RE: Advice on Environmental Impact Statement – 130 Wentworth Avenue, Banksmeadow (SSD-73846459)

Attachment A: State Significant Development Application – 130 Wentworth Avenue, Banksmeadow

Figure 2: Trees located on property surrounding the current building

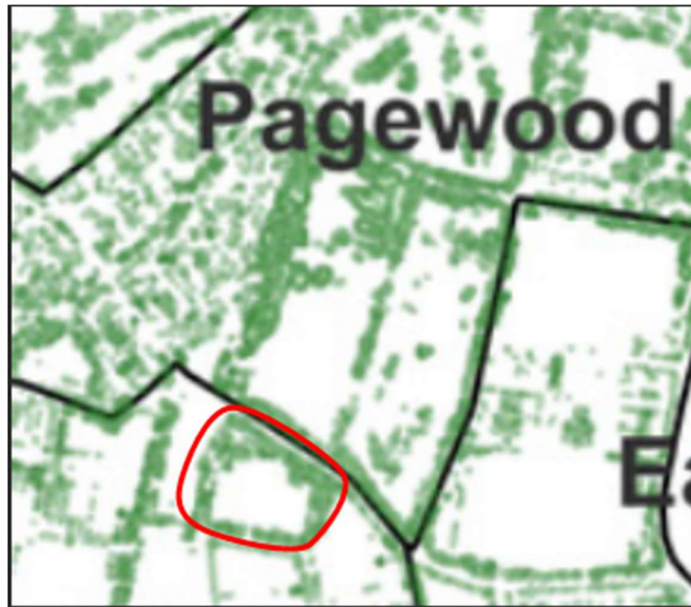
- Council's Environment and Resilience officers raised concern in relation to the loss of a significant number of trees and associated habitat within the site.

- 798 trees are present on site (721 trees are protected, 80 are native, and 456 are indigenous. 77 trees are exempt via BDCP 2022 and 13 trees are exotic). The SSDA seeks to retain 277 of the existing 798 trees and remove 521 existing trees (65% loss of individual trees). Removal of 521 trees includes: 166 High Retention Value trees; 215 Medium Retention Value trees; and 67 Low Retention Value trees. 188 new trees will be planted. This equates to a net loss of 333 trees or 42% loss of individual trees, based on an assumption that all new 188 trees would reach maturity at some point in the future.

- Provide evidence on how the proposed on-site canopy (estimate at maturity) will achieve 7,954m² (Appendix H Landscape Plans Drawing C-TP2),
- Specify how the loss of Grey-headed Flying-fox food resources from removal of 66 Eucalypts trees, Callistemon species (total tree number not stated in BDAR Waiver) and the fruits of 18 *Ficus rubiginosa* and *F. benjamina* trees will be replaced by new tree planting on site,
- Tree offsets to be implemented as per BDCP 2022, and
- Tree pot size to be 100L minimum as per BDCP 2022.

Figure 5: Truck driveway entry to level 1 and truck driveway exit from ground floor:

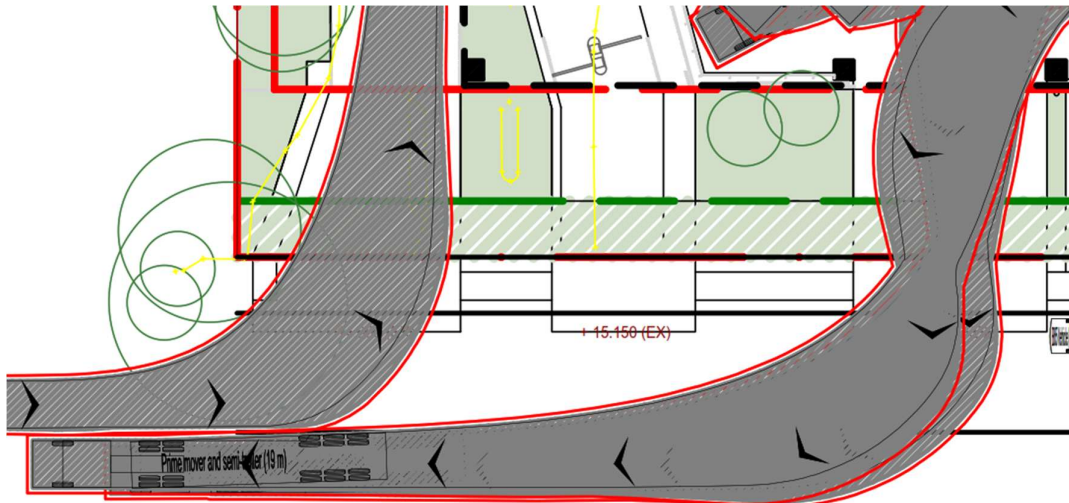
- The submitted truck swept paths in the TIA make it evident that truck driveways both into and out of the ground floor and the truck driveway to level 1 need to be widened within the site. In their current design, on-street parking next to these driveways will interfere with truck swept paths. These driveways shall be revised to provide splays in the site extending out to the area adjacent to the driveway where on-street parking would otherwise interfere with the swept paths of trucks. It's noted that due to the street tree adjacent to the truck entry driveway to level 1 that a splay is not possible and other driveway modifications or signposting are necessary to facilitate swept paths.
